RE: Submittal 130383-006 for the Controlled Temperature Room at Webster University Science Building

Copies	No.	Description
1 PDF	130383E01A	(Submittal No.'s:) (R&B CxSRC) - Resubmittal
		(Cannon #130383- 005 REV002)-(Paric #15051-0489)-(WES #607)
		➤ Cold Room Shop Drawings

PROJECT: 15051-Webster University Interdisciplinary Science Building

RE: Cold Room Shop Drawings REV1

COORDINATION NOTES

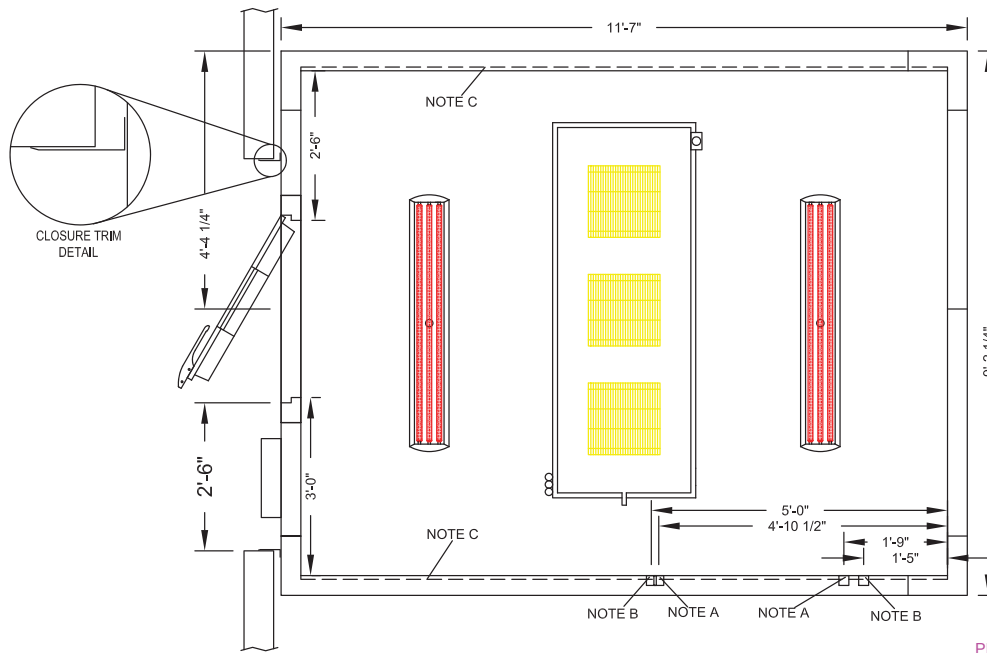
10. **GC to confirm dimensions work with the floor depression provided.**
BioCold will also field verify all dimensions prior to fabrication.
11. **Relocate GFCI receptacles to 42" AFF.**
Please confirm desired receptacle height. The specification indicates that the receptacles should be 42" AFF **unless otherwise noted**. The elevation on A0615/14 clearly scales the receptacles at 48" AFF on center. We are more than willing to relocate the receptacles to 42" AFF on center, but want to confirm that this will not interfere with the casework/counters.

- NOTE A:** 2"x4" J-BOXES WITH 3/4" CONDUIT MOUNTED WITH CENTERED AT 48" AFF AS SCALED FROM A0615.14 FOR GFCI. GFCI TO BE POWERED FROM BIOCOLD CONTROL PANEL. **42"**

- NOTE B:** 2"x4" J-BOXES WITH 3/4" CONDUIT MOUNTED AT 18" AFF ON CENTER FOR GFCI. GFCI TO BE POWERED FROM BIOCOLD CONTROL PANEL.
- NOTE C:** BIOCOLD TO PROVIDE 14GA GALVANIZED BACKING FULL HEIGHT OF WALL PANELS FOAMED INTO WALL PANELS AS SHOWN FOR WALL-MOUNTED SHELVING OVER COUNTER. ALL CASEWORK, COUNTERS, SINKS, AND SHELVING BY OTHERS.

SEISMIC ANCHORAGE DETAIL

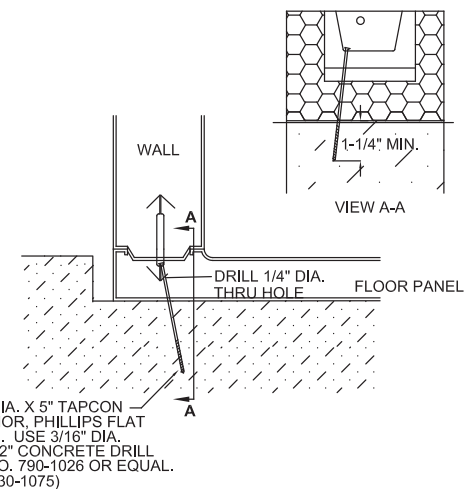
3. **Provide equipment anchorage information per 1.4.B**

Please see updated shop drawing showing equipment anchorage detail(s).
